**DHSS HOLLOWAY CHAPEL ADMINISTRATION BUILDING
HOUSEKEEPING RENOVATIONS
HOLLOWAY CAMPUS, NEW CASTLE, DELAWARE
DBF #586B035.J01 □ OMB/DFM# MC350100025
JULY 23, 2015**

ADDENDUM NO. 2

ADDENDUM NO. 1

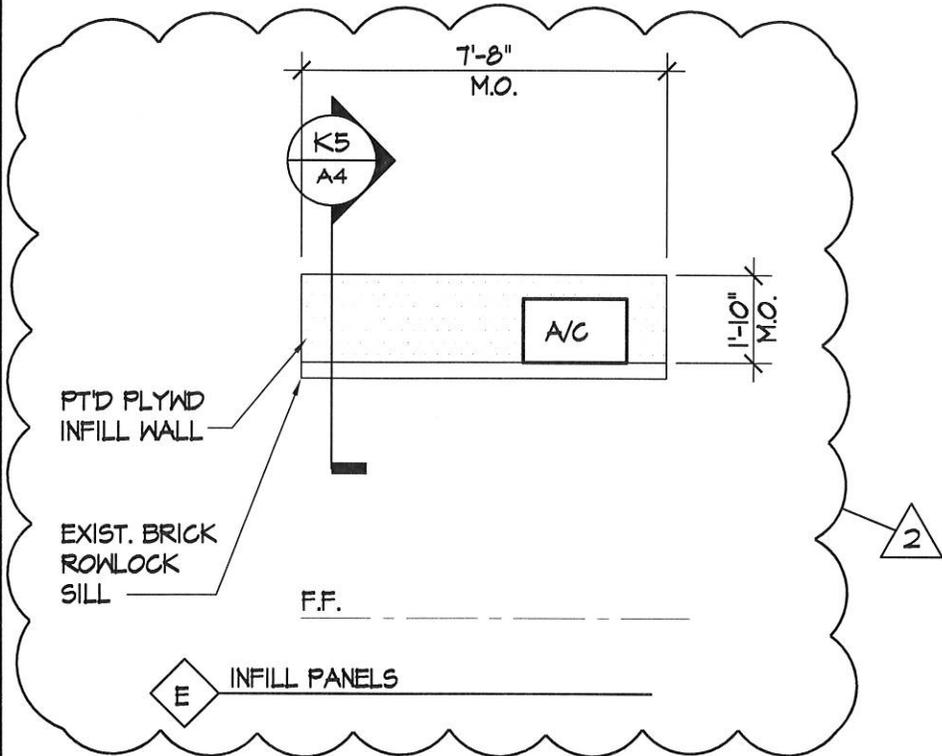
- Add the attached Sketch SKE-1. Refer to the attached Sketch SKE-1 for location of existing bus duct plugs & approximate conduit and feeder routing to existing Panels HK1 & HK2 in the 2nd Floor Housekeeping Area.

Q2: Can you provide the location and distance from project to main panel board that the existing HK1 and HK2 are fed from shown on drawing E4?

A2: *The new feeders for Panels HK1 & HK2 will be connected to the existing bus duct system, not directly to the main electrical distribution panel. Refer to attached Sketch SKE-1 for location of existing bus duct plugs. Estimated distance from bus plugs to panels are approximately 150 ft. Existing 3P-100A circuit breakers in Bus Plugs shall be reused.*

A9.4

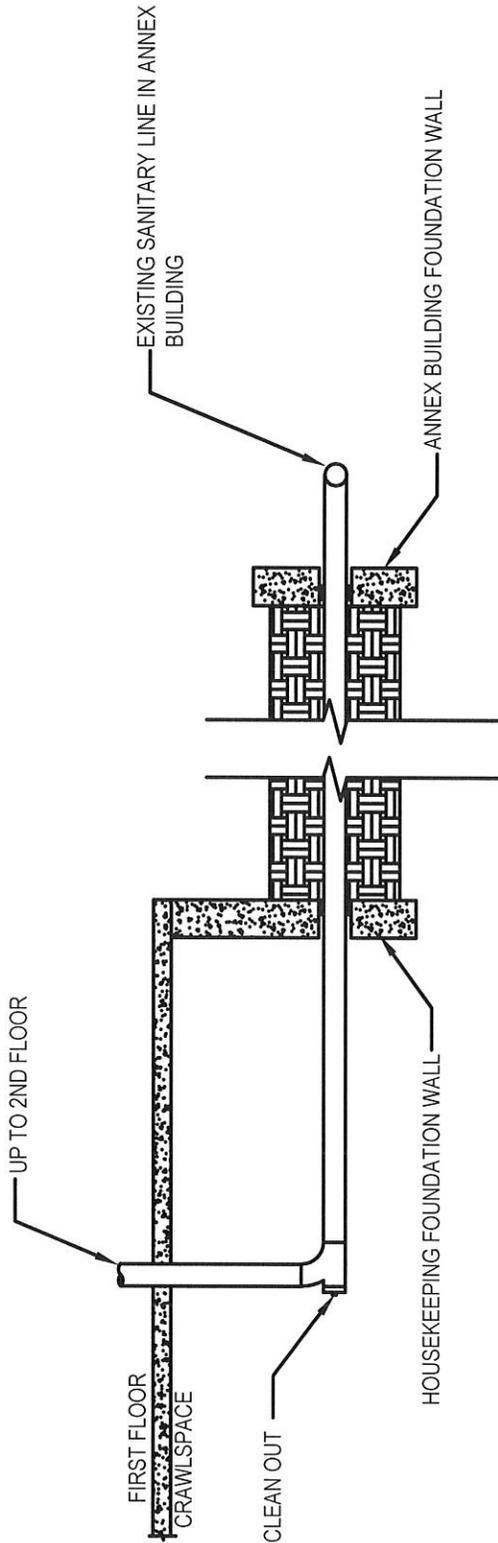
- The attached Sketch A9.3 adds Window Type E. This window type is located at Office 3.
- Item No. 4 See attached Sketch A9.4. This sketch adds a stud and gypsum board chase at the proposed sanitary line at the First Floor.

1. THIS DRAWING ADDS A STUD AND GYPSUM BOARD CHASE AT THE PROPOSED SANITARY LINE AT THE FIRST FLOOR. ADDENDUM #2 (7-23-15)

2 INDICATES REVISION: ADD CHASE AT PROPOSED SANITARY LINE

STUD WALL CHASE (SIM. TO PARTITION TYPE 2A) APPROX. 10'-0" HIGH WITH 12"x12" ACCESS PNL.

Dwg.No.:
SKP-2

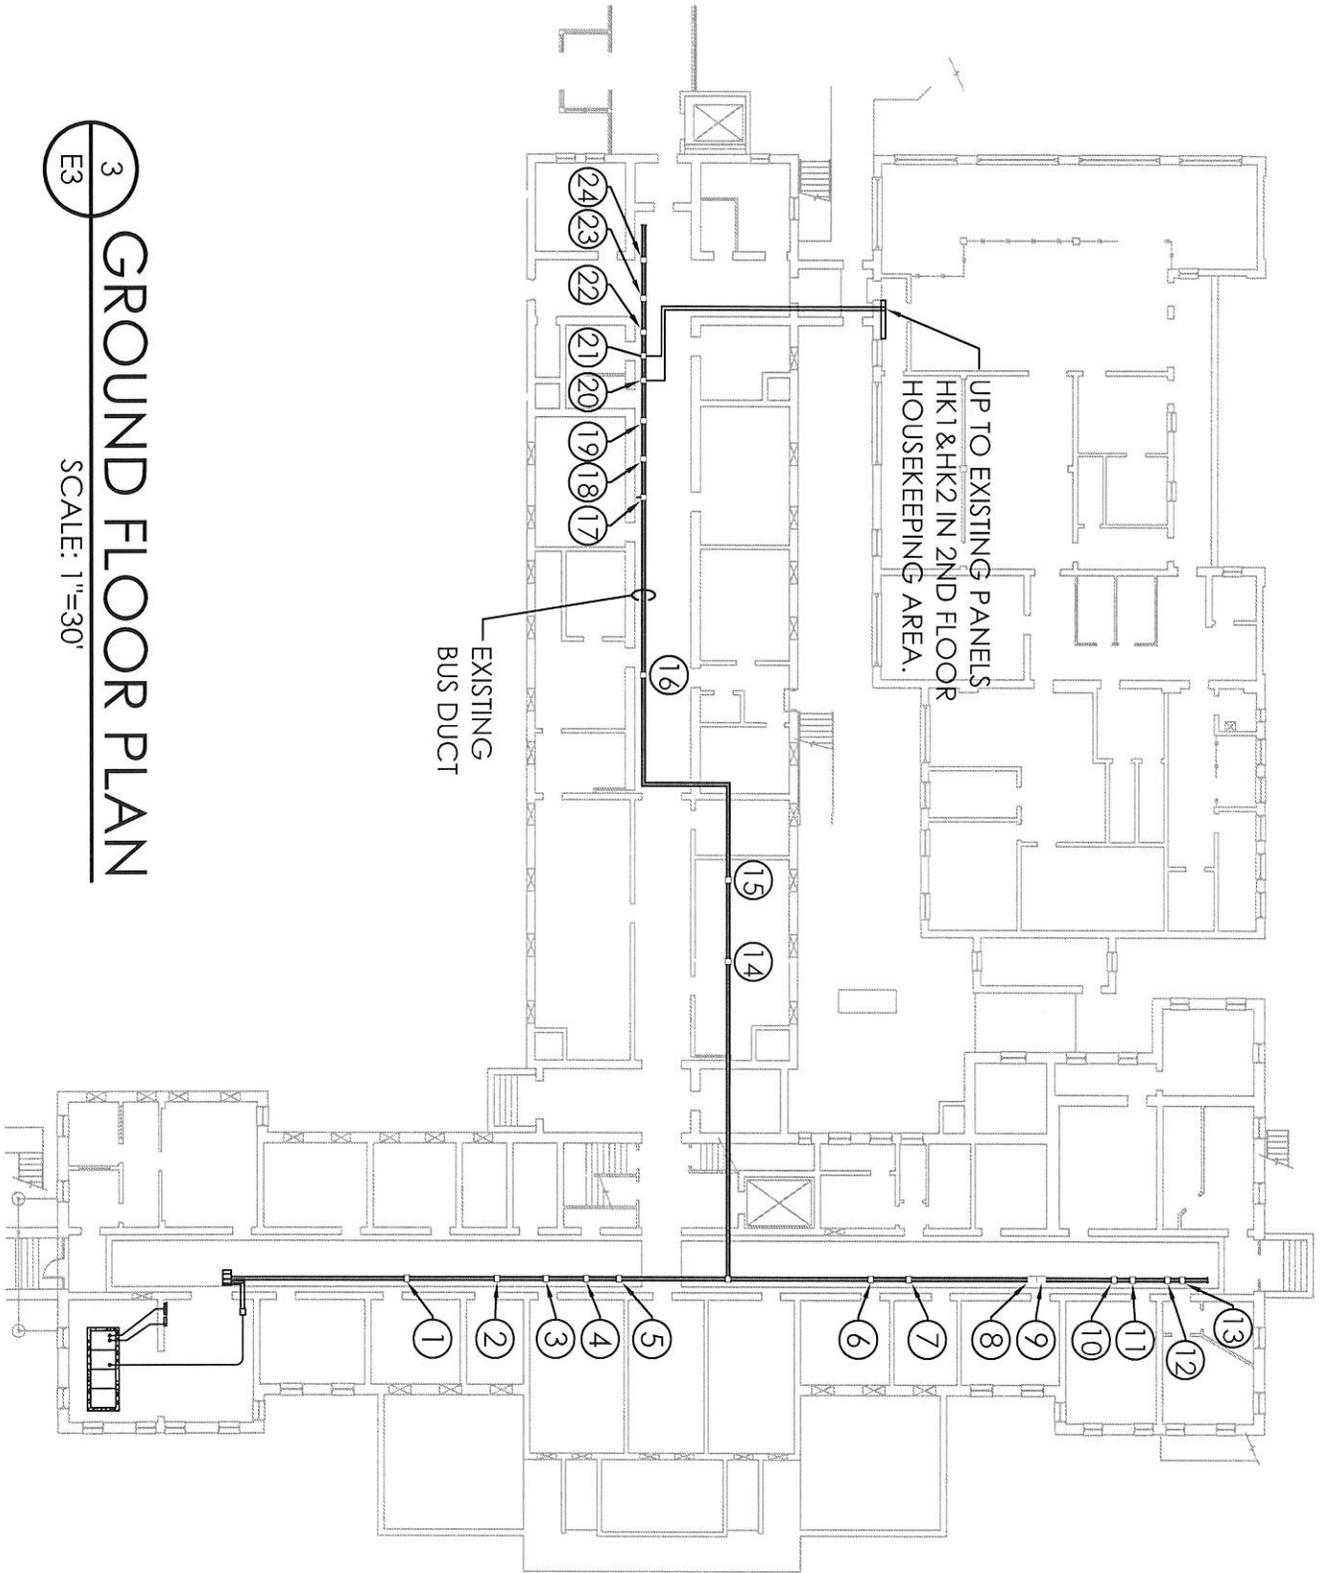
- Item No. 5 Refer to Drawing Sheet P2
- Add the attached Sketch SKP-2. Refer to the attached Sketch SKP-2 for sanitary piping routing detail.
- Item No. 6 Refer to Drawing Sheet E3

Q1: Can you clarify if the new 4 inch sanitary is going to be above ground, or does it require burial as shown on the docs?

A1: *The sanitary piping shall be routed into the crawlspace below the first floor and below grade over to the existing sanitary line located in the Annex basement. Refer to attached sketch SKP-2 for clarification.*

4" SAN DOWN TO CRAWLSPACE. CORE DRILL AND FIRE CAULK AT FLOOR PENETRATION. PROVIDE CLEANOUT AT TOP AND BOTTOM OF DROP.

Dwg.No.: **A9.2**

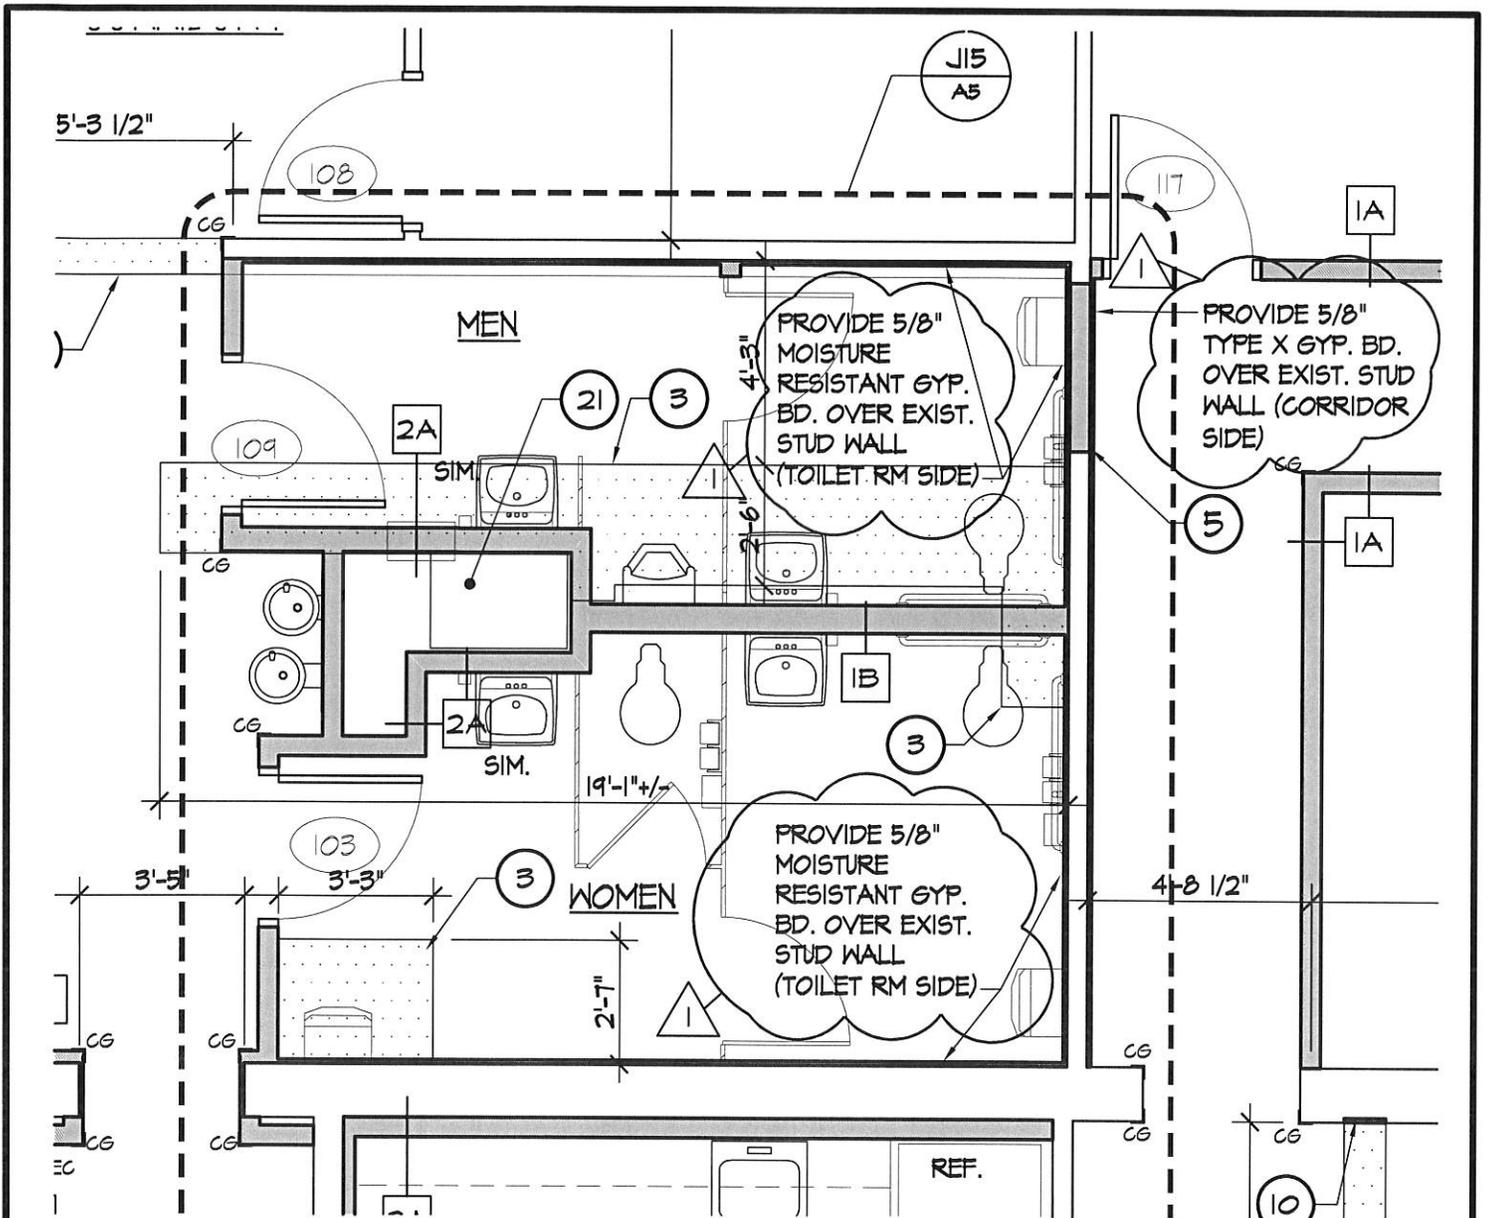
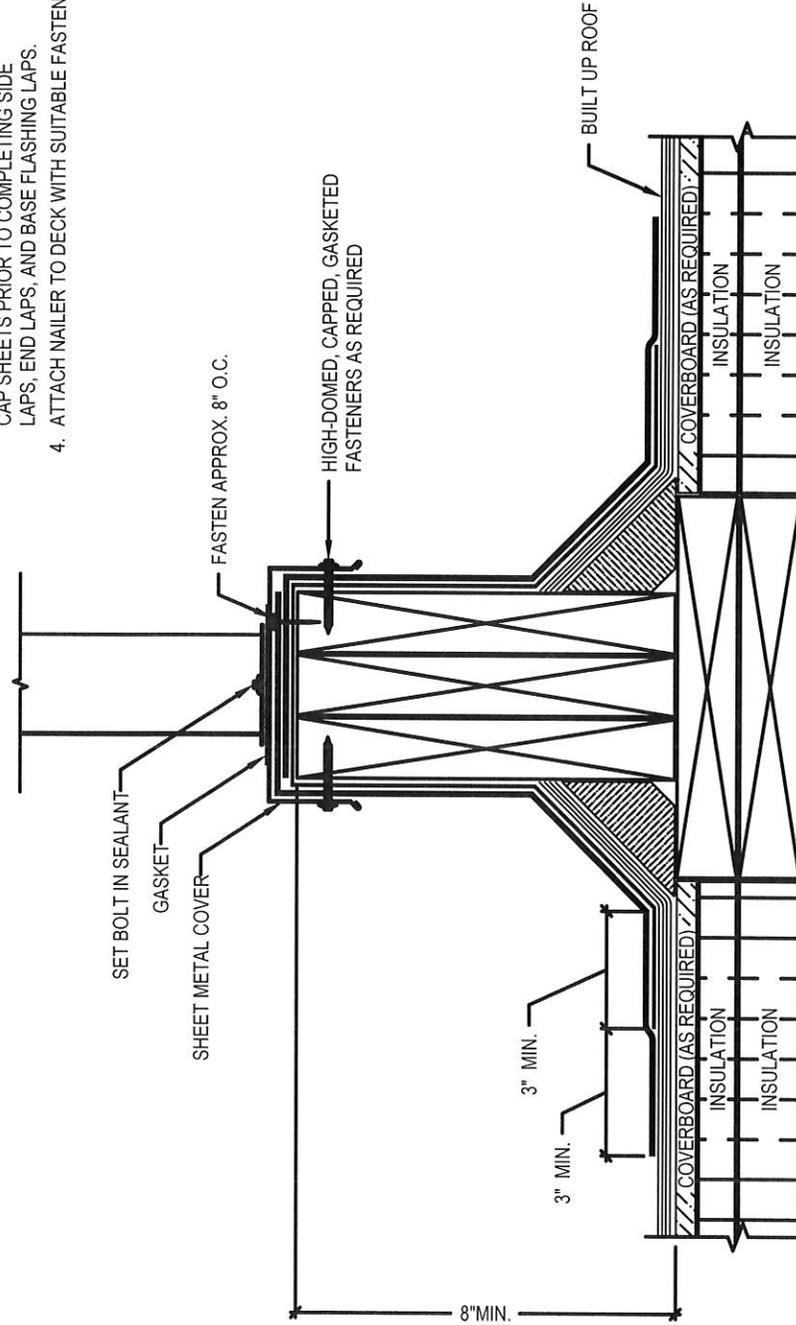
- See attached sketch A9.2. Additional Gypsum Board to be laminated to existing walls in Toilet Rooms and adjacent Corridor.
- Item No. 4 Refer to Drawing Sheet A2

1. THIS DRAWING REVISES FLOOR PLAN 01 ON SHEET A1 AND IS INCLUDED IN ADDENDUM #1 (7-20-15)

INDICATES REVISION: ADD GYP. BOARD AT EXISTING WALLS

SKM-1

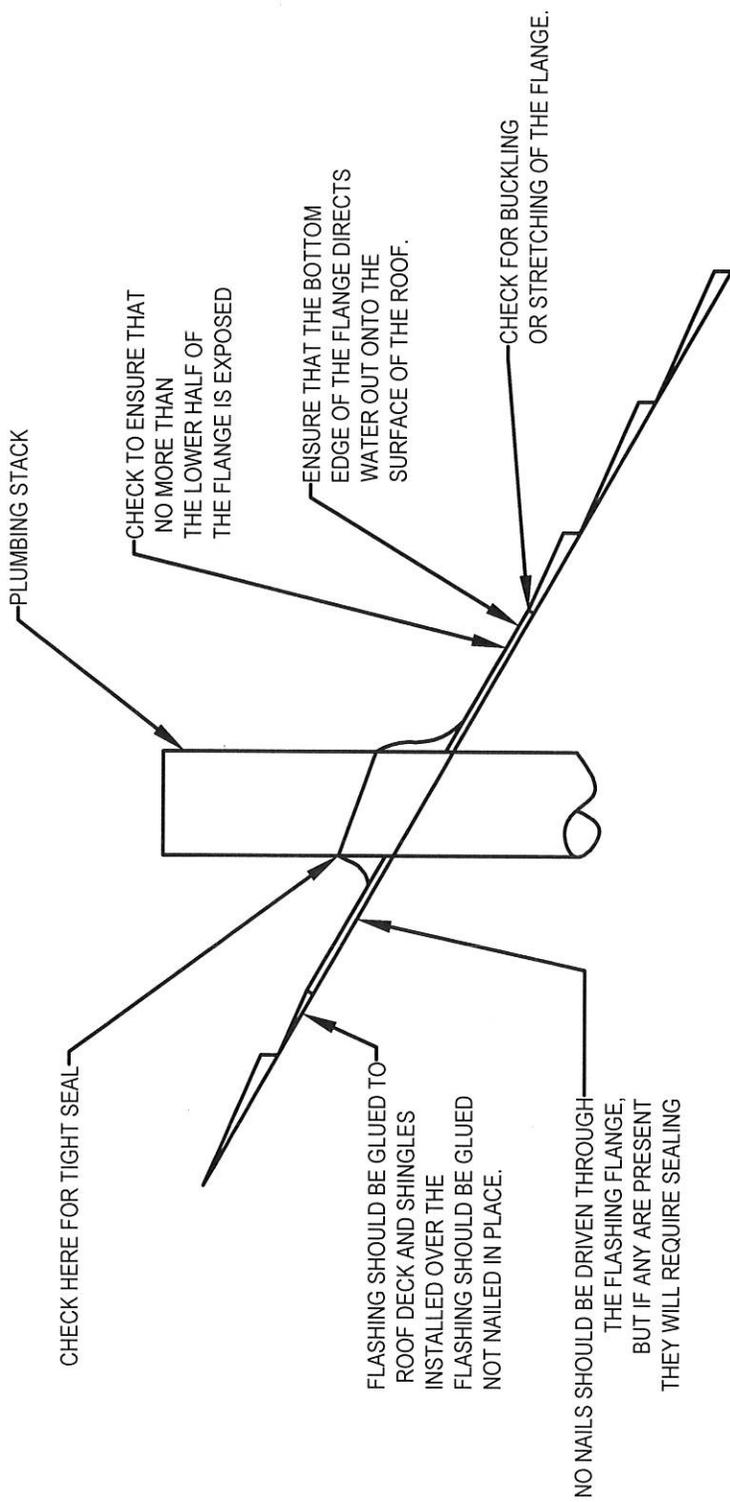
- On Drawing O7 PARTIAL FIRST FLOOR PLAN (ALTERNATE #1), delete (2) Elevation Marks referencing O10/A3.
- Item No. 5 Refer to Drawing Sheet M3
- ADD Sketch SKM-1. Refer to the attached Sketch SKM-1 for installation of the new equipment support rails for HP-1 & HP-2 on the existing flat roof.
